PROJECT: THE WORLD TRADE CENTER | TITLE: EXTERIOR WALL - TRUSS SEAT REPAIR | DATE: 9/2/69

19-AB-959

Detail A

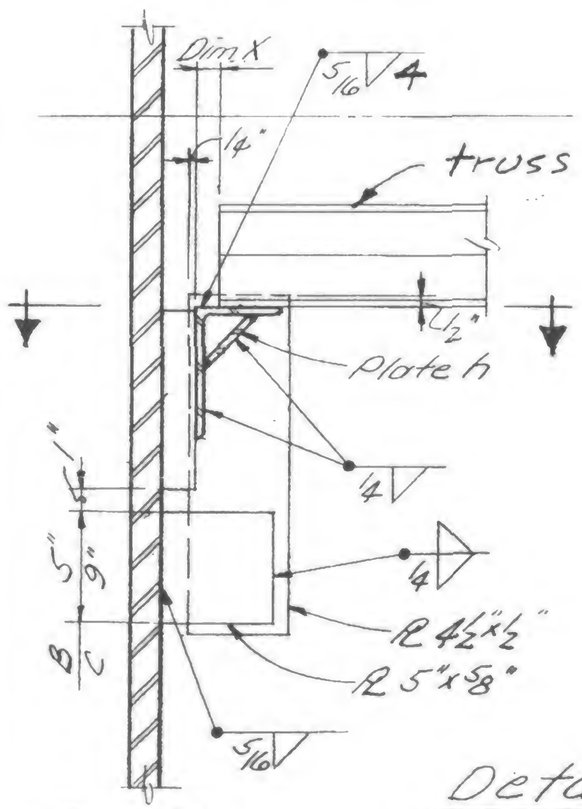
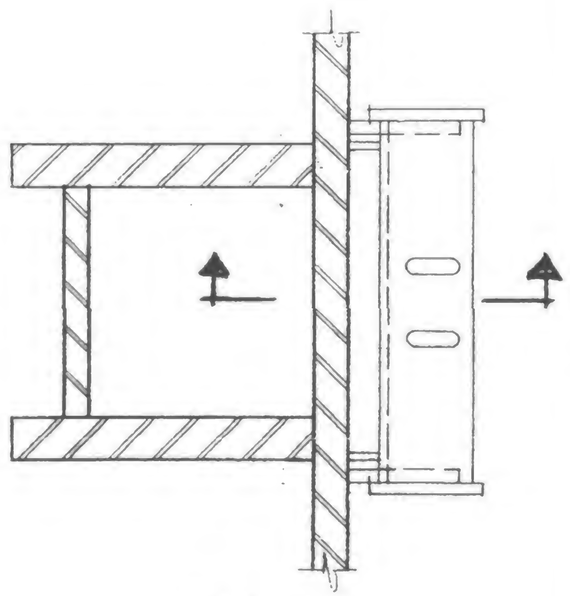
SCHEDULE OF REPAIR DETAIL						
DIM. X	FLOORS					
	10-40	44	45-48	49-74	78	79-106
To 1/16"	None	None	None	None	None	None
1/8" to 1/2"	A	A	A	A	B	A
9/16" to 1"	A	B	A	A	B	A
1 1/16" to 1 1/2"	A	B	A	B	B	B

Note: Where repair is required, it is likely that damper connection will not mate. See 19-AB-960 for repair.

Detail of Plate h

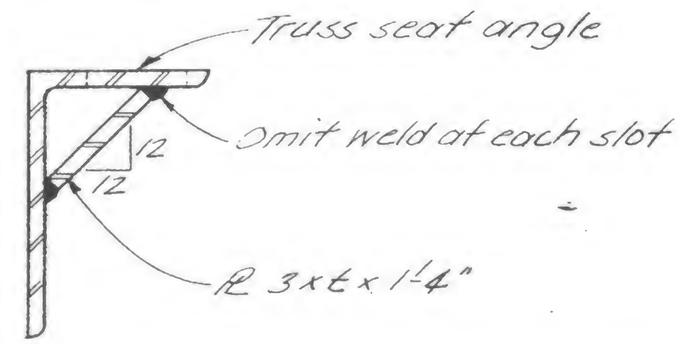
Floors 10-40, 45-74, 79-106
t = 5/16" typical, except
t = 3/8" @ Cols. 111, 149, 217, 243, 311, 349, 417 & 443

Floors 44 & 78:
t = 1/2" typical, except
t = 5/8" @ Cols. 111, 149, 311 & 349
